Groundwater Application Review Summary Form

Application # G- 18573

PUBLIC INTEREST REVIEW FOR GROUNDWATER APPLICATIONS

TO: Water Rights Section Date 1/17/2018
 FROM: Groundwater Section Benjamin Scandella, Dennis Orlowski
Reviewer's Name
 SUBJECT: Application G- 18573 Supersedes review of _____
Date of Review(s)

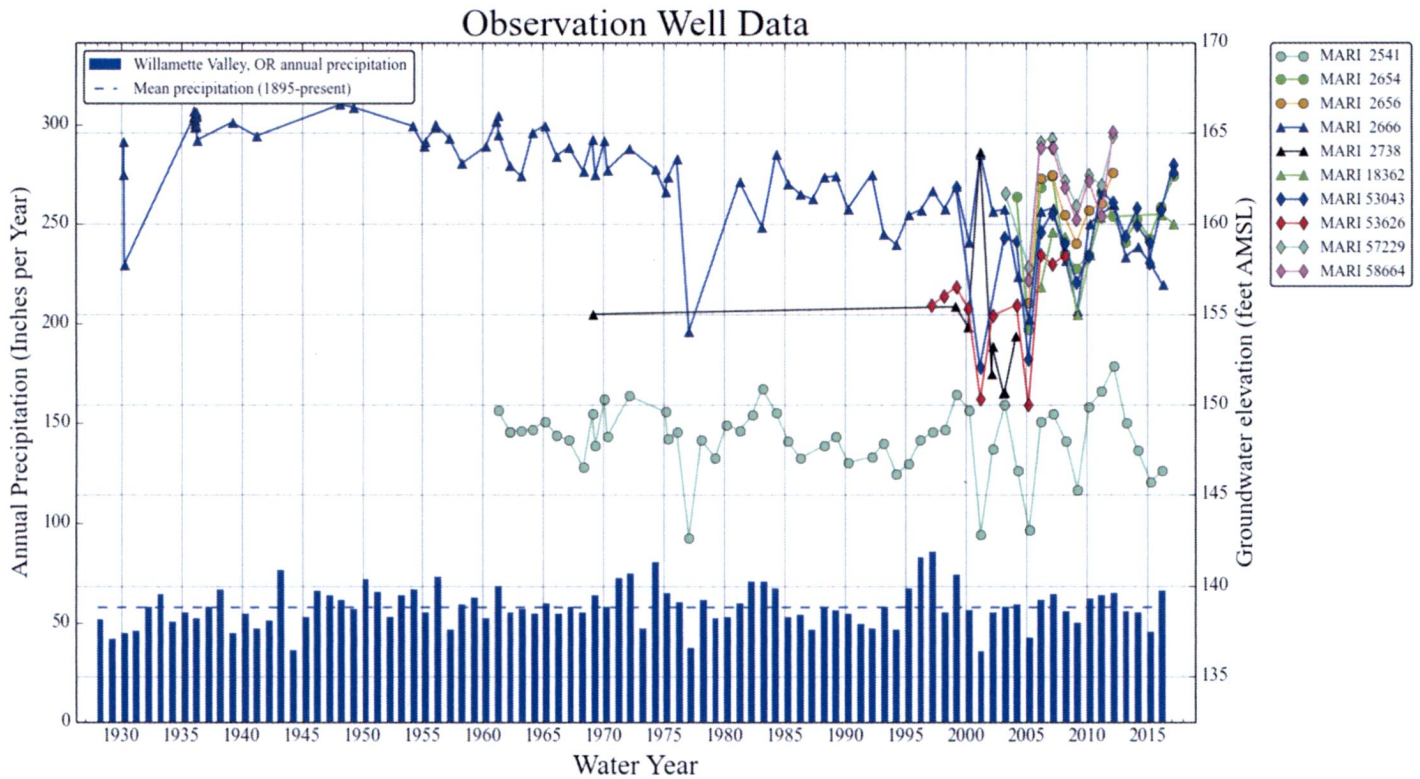
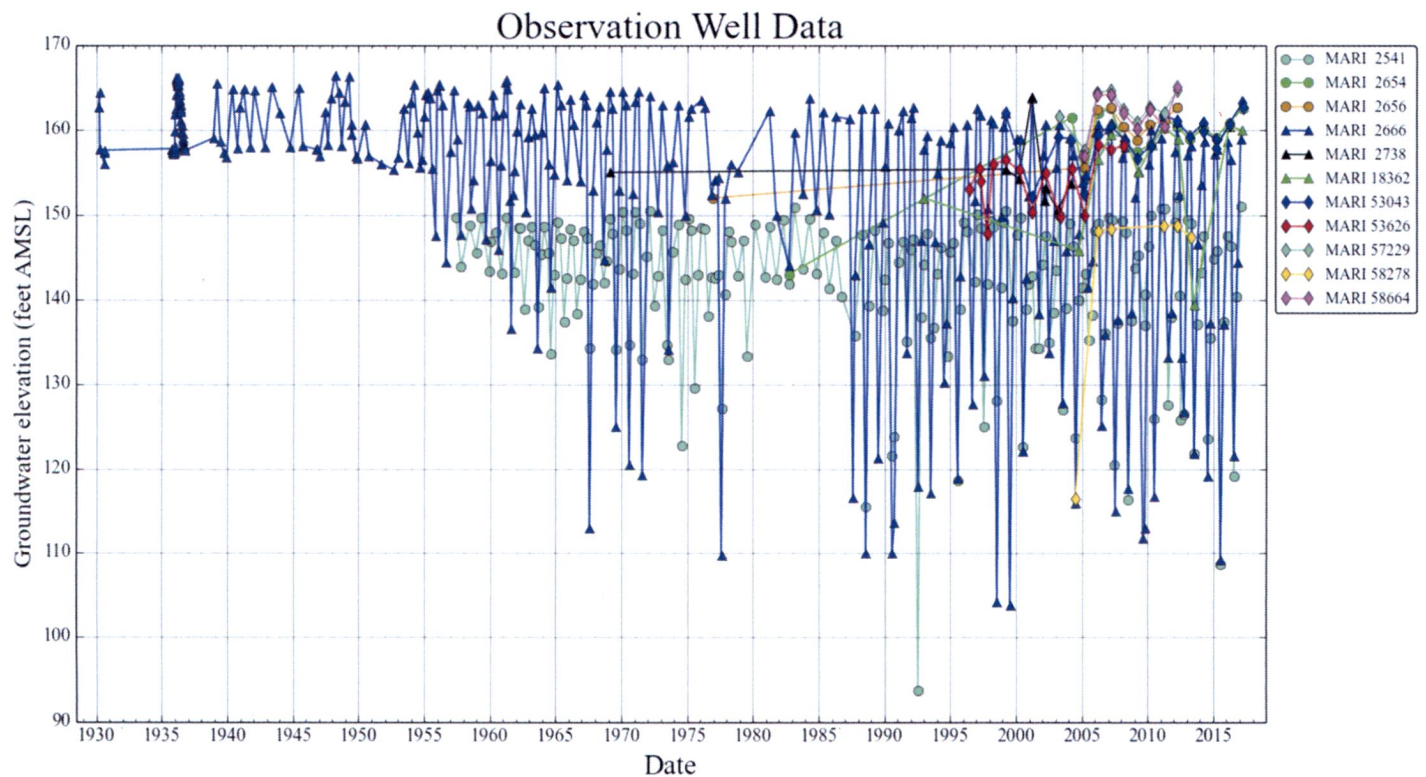
The water table is about 10-30 feet below land surface. Water level data available from nearby wells in the sedimentary aquifer system show fairly stable trends over the past 85 years (see attached hydrographs). However, water-level data from MARI 2541 and MARI 2666 indicate that seasonal fluctuations range from 20-60 feet. These seasonal fluctuations are consistent with those found in much of the alluvial aquifer of the central Willamette Basin and likely reflect the combined interference from irrigation wells (Conlon and others, 2005).

All measurements from wells in the same spatial region as above, showing typical seasonal variability of 20-30 feet closer to the Willamette River to the west (for example, MARI 2541) and more than 50 feet to the east (for example, MARI 2666).

The stable annual water levels in nearby wells indicate that groundwater for the proposed use is likely available within the capacity of the resource, but if a permit is granted, the recommended permit conditions should be included to monitor and protect the resource.
